Sub: Corrigendum-01: Amendment to Tender specification document & due date extension

- 1. E-Tender specification No: 2101094
- 2. **Scope of work:** Detailed drawing preparation based on Input design drawings provided by BHEL-Engineering Centers for Flue Gas Desulphurization (FGD) Package as specified in scope and getting approval from BHEL- Engineering Centers/ NTPC. Fabrication and supply of finished product (procurement of raw structural steel will be in the scope of bidder) i.e. structures of FGD as per BOM/Drawings at 2X500 MW NTPC Mauda, Stage-I, TPP-FGD, Maharashtra.

2 X 500 MW MAUDA STPP-FGD PACKAGE			
DWG / DOC NO AND TITLE : 9561-109-ISG-PVC-B-445 - CONVEYOR LBC-1AB-GA OF GALLERY & TRESTLES R0				
SL NO	NTPC COMMENTS	BHEL REPLY		
1	Hold	Staad file has been revised and errors resolved		
2	PTFE bearing shall be provided for slinding support	Accepted. PTFE indicated in elevation view.		
3	COMPLY TO COMMENTS MARKED DESIGN DOCUMENT	Complied		
4	DESIGN/DRAWING TO CONFORM TO LATEST MECHANICAL/ELECTRICAL GADRG.	Accepted. Trestle Tr-2A introduced for structural requirement, after discussion with mechanical. The same will be updated in Mech GA dwg.		
5	ALL FURTHER CHANGES TO BE I

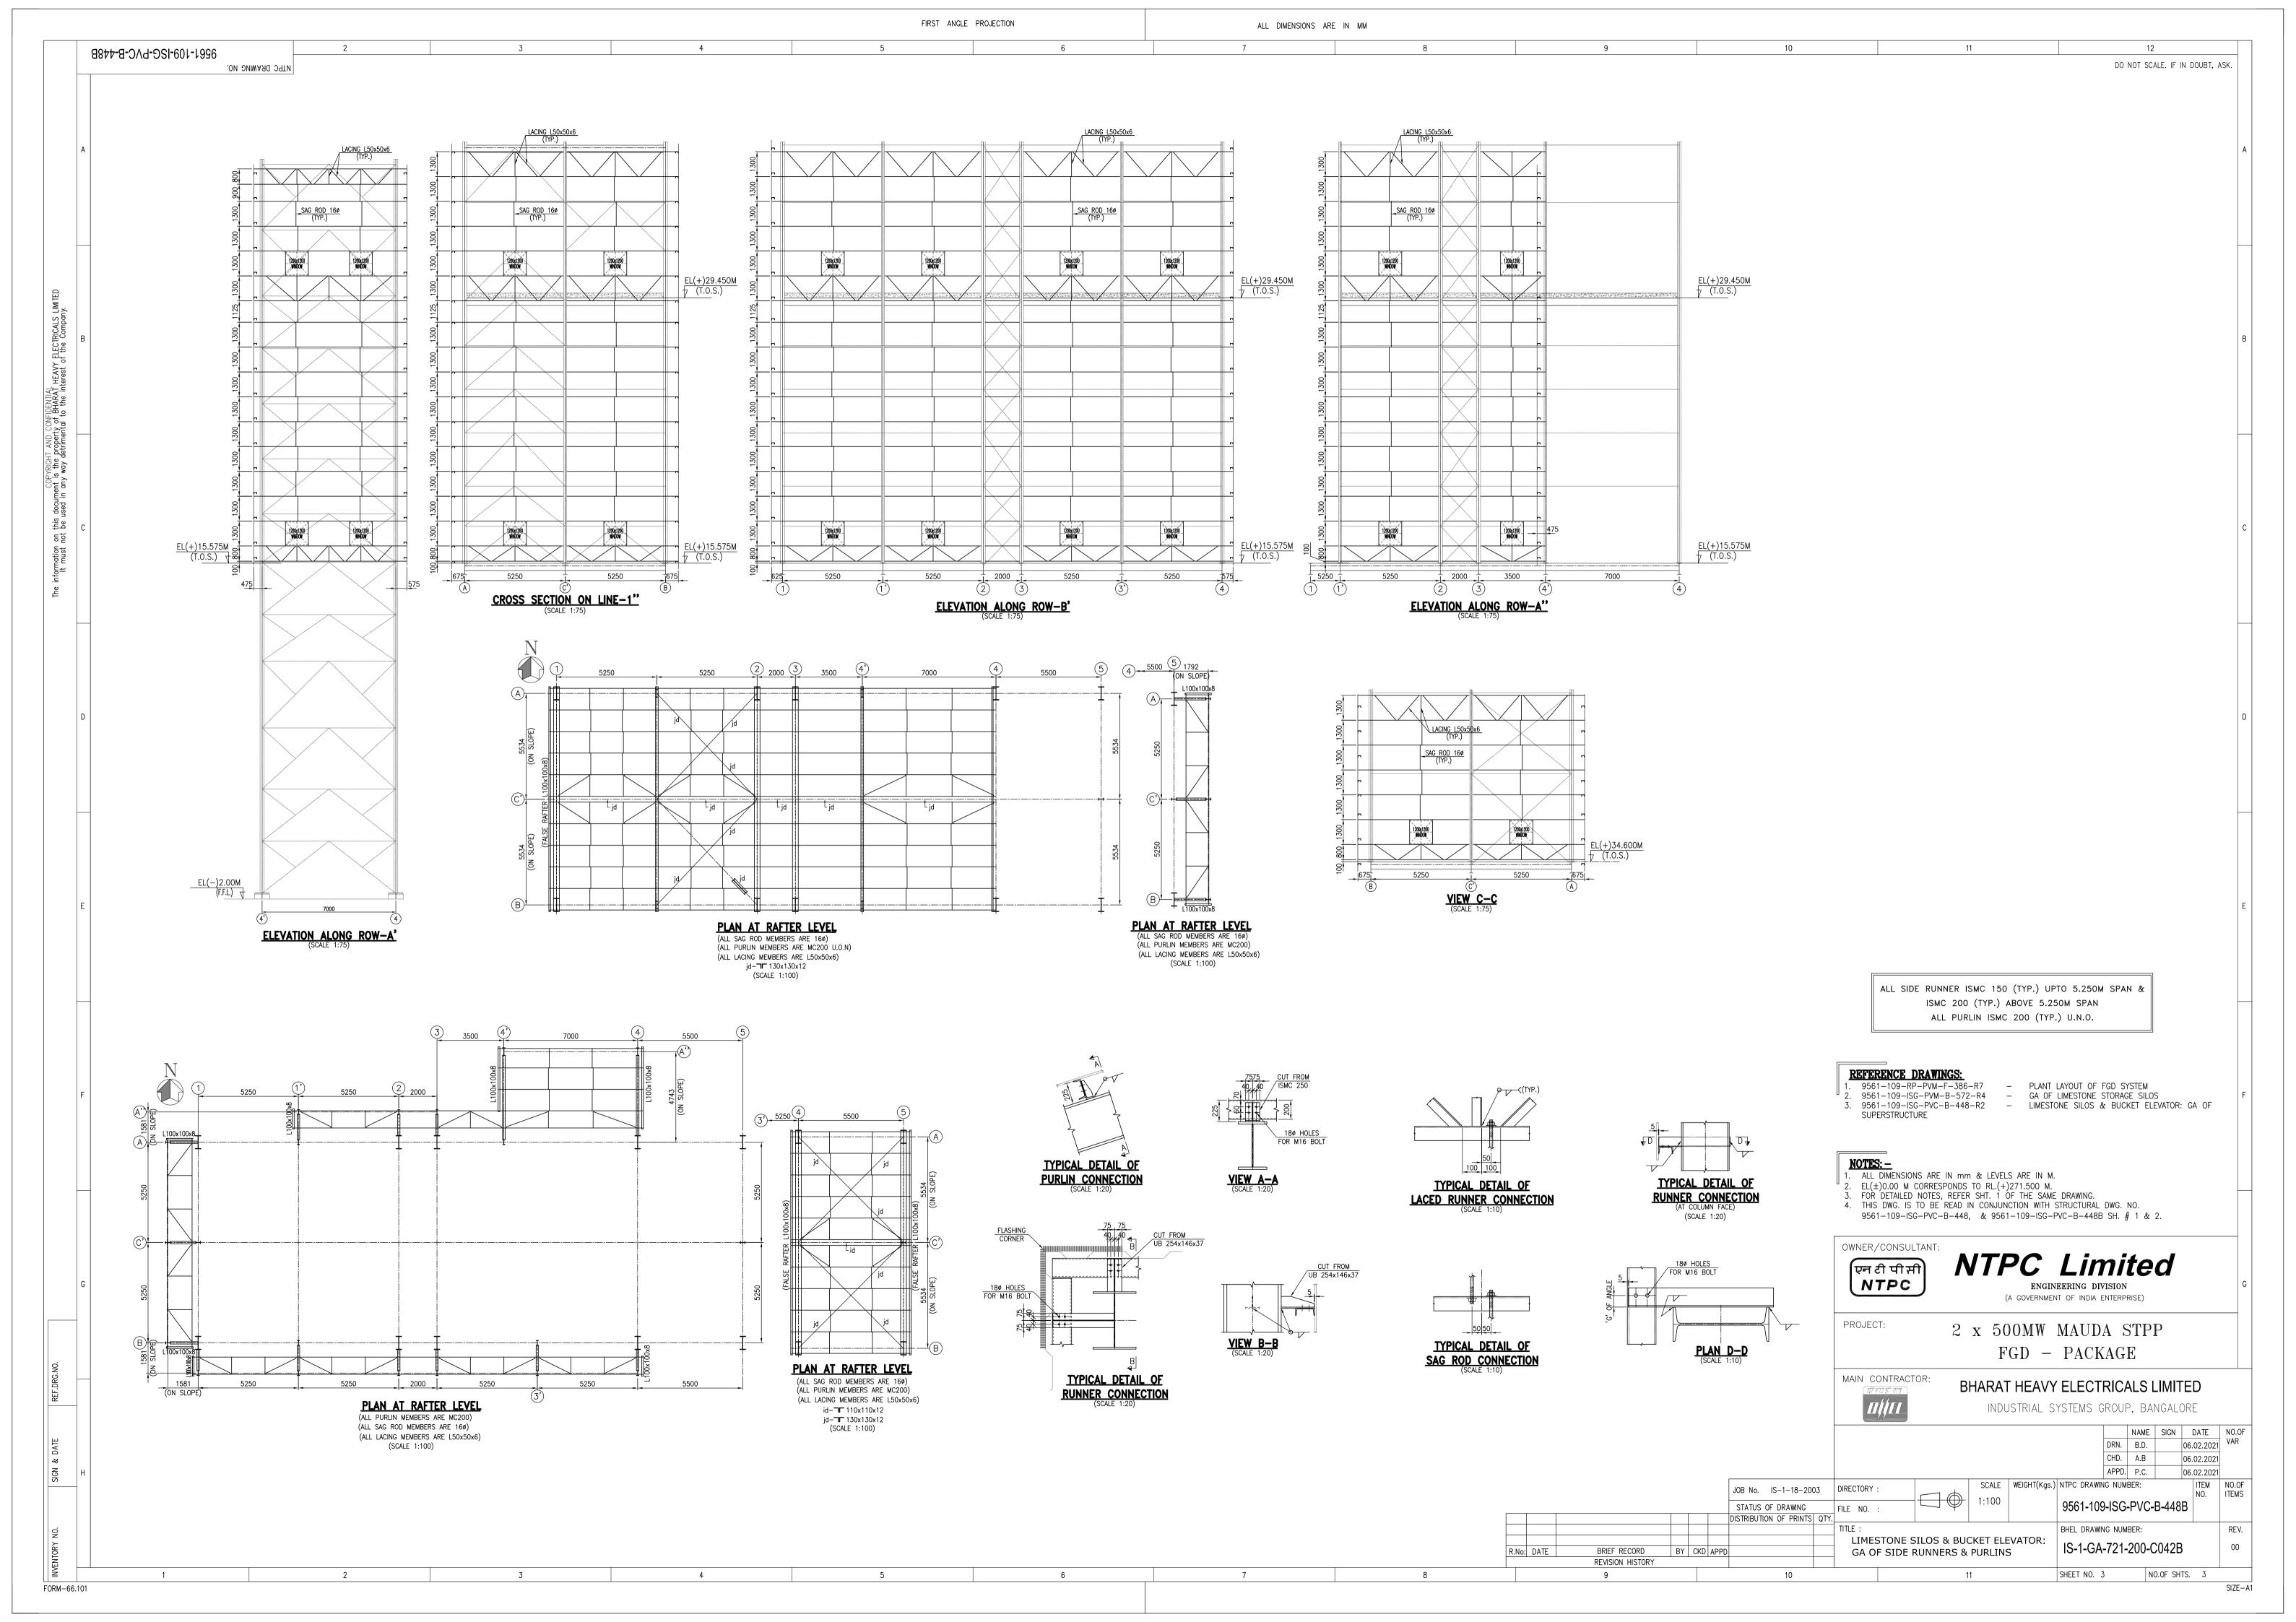
8	Design and Detailing of connections shall be done as per section 10 and section 12 of IS 800:2007.	Ok. The same has been incorporated in Notes
